## SERVICE BULLETIN

"L" SERIES STATION WAGONS  
1985 MY THROUGH 12/90 PRODUCTION

**SUBJECT: RATTLING NOISE OF REAR GATE DOOR ON "L" SERIES STATION WAGONS**

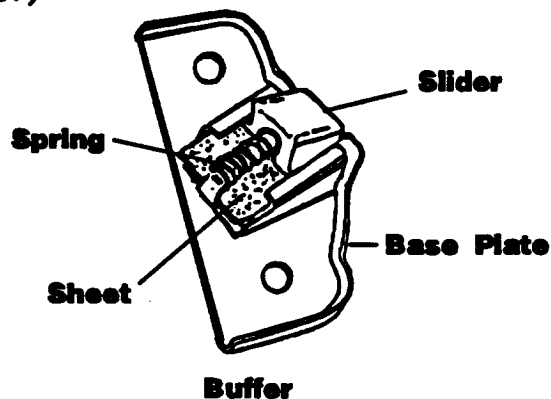
If you encounter a customer complaint of a rattling noise from the rear gate area it may be necessary to install a plastic sheet into each buffer assembly after eliminating other possibilities.

The part number for the sheet is 60109GA070, package quantity 1, and can be obtained through normal parts channels. The procedure will require two sheets, one for each buffer assembly.

2. Depress spring towards slider and remove.
3. Remove slider from buffer base plate.
4. Insert sheet into buffer base plate.
5. Apply grease on sheet, Silicolube G-30, P/N 004404002 or equivalent is recommended.
6. Re-install buffer assembly and spring.
7. Re-install shim(s) during buffer installation, if necessary. Tighten the buffer mounting bolt to 5.4-9.3 Nm (0.55-0.95 Kg-m, 4.0-6.9 ft. lbs.)

With rear gate closed, check to see that buffer slider has moved by looking through the gap between the rear gate and rear combination light. If slider does not move far enough, adjust slide stroke with spacer(s). One spacer can change slide stroke by about 3 mm (0.12 in.).
